**OBJECTION TO DEVELOPMENT APPLICATION DA2024/1707**

18 HILLCREST AVE MONA VALE - DWELLING [24\_066]

Re: Building impact on Norfolk Pine at  
No. 18 Hillcrest Ave Mona Vale 2103

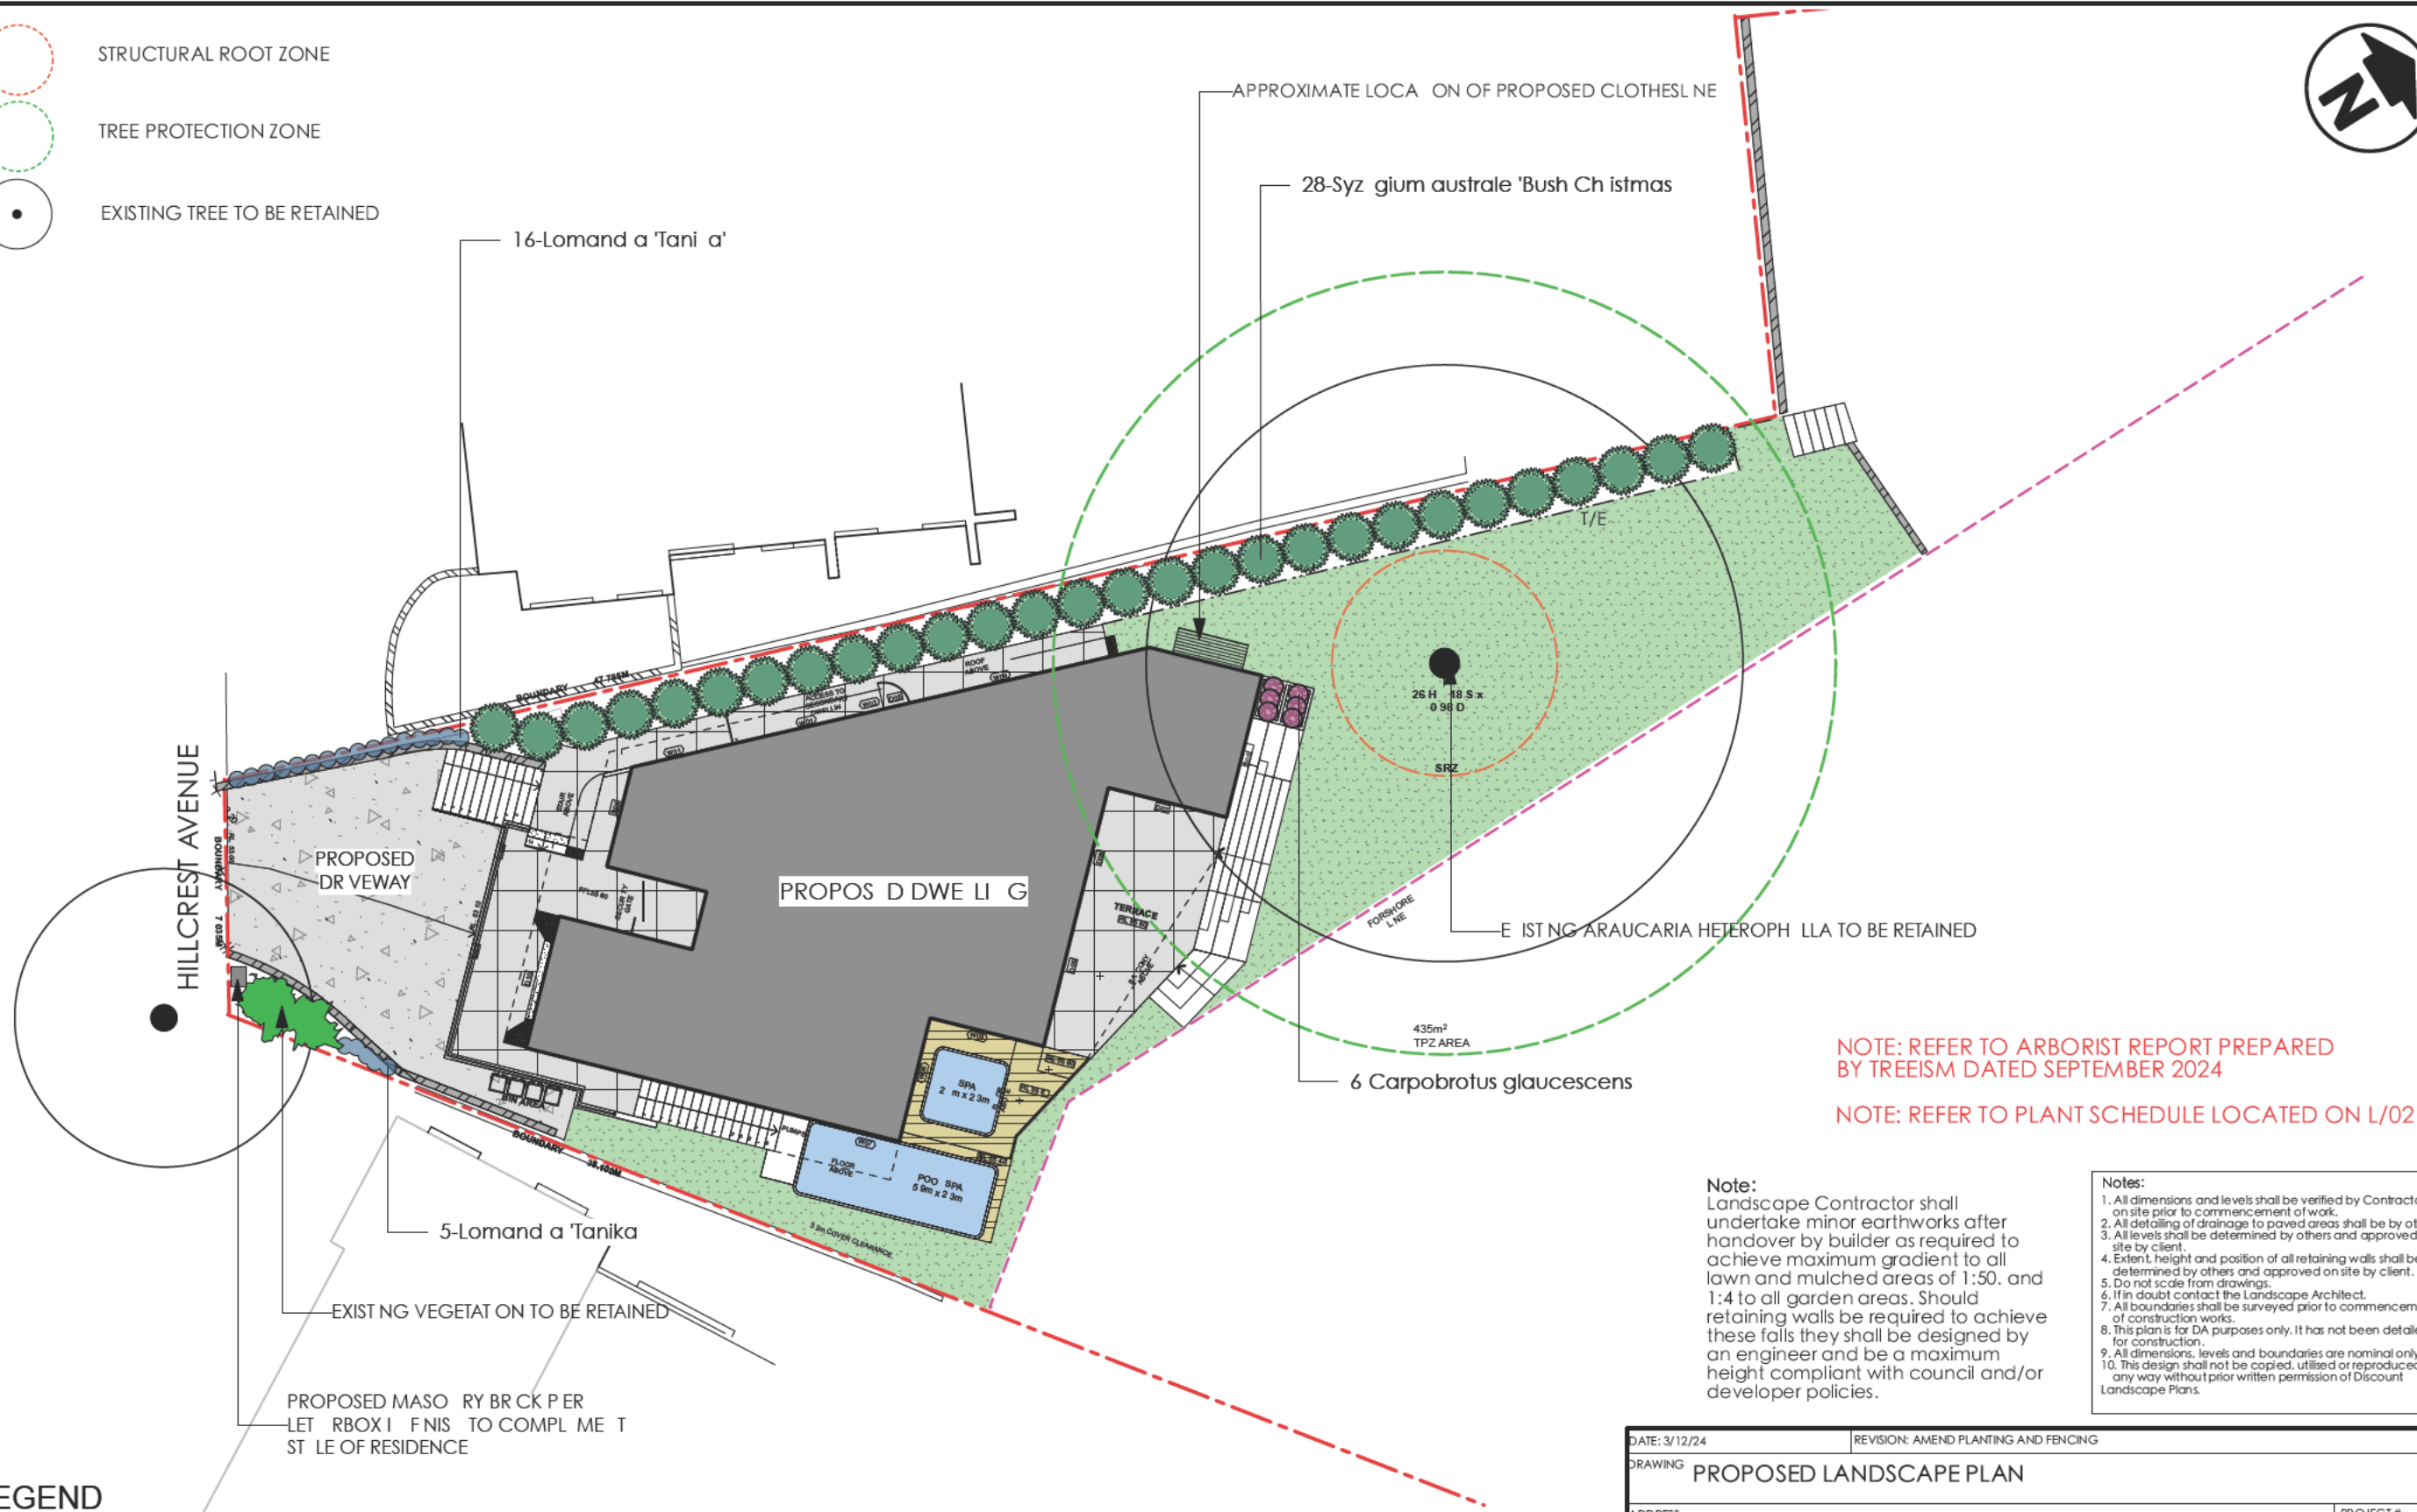
The development proposes a hedge along the eastern boundary comprising *Syzygium Australe* 'Bush Christmas' that has a mature height of 3m (according to the landscape plans that form part of the application).

There is currently an open fence located on the common boundary that provides views from the pool and rear garden to the ocean. The proposed hedge would completely obstruct these views.

The 3m hedge will also block views to the ocean (particularly when looking north east) from the upper living room of the dwelling.

We request that the development be amended so that when measured along the common boundary:

- Species changed to one that grows to a lower mature height.
- Maximum height of hedge is 2m, and does not extend closer than 14m from the rear boundary
- Any remaining hedge along the boundary to have a mature height of no more than 1m high, except that
- The most northern most 6m retains the open fence and planting is no higher than 0.6m
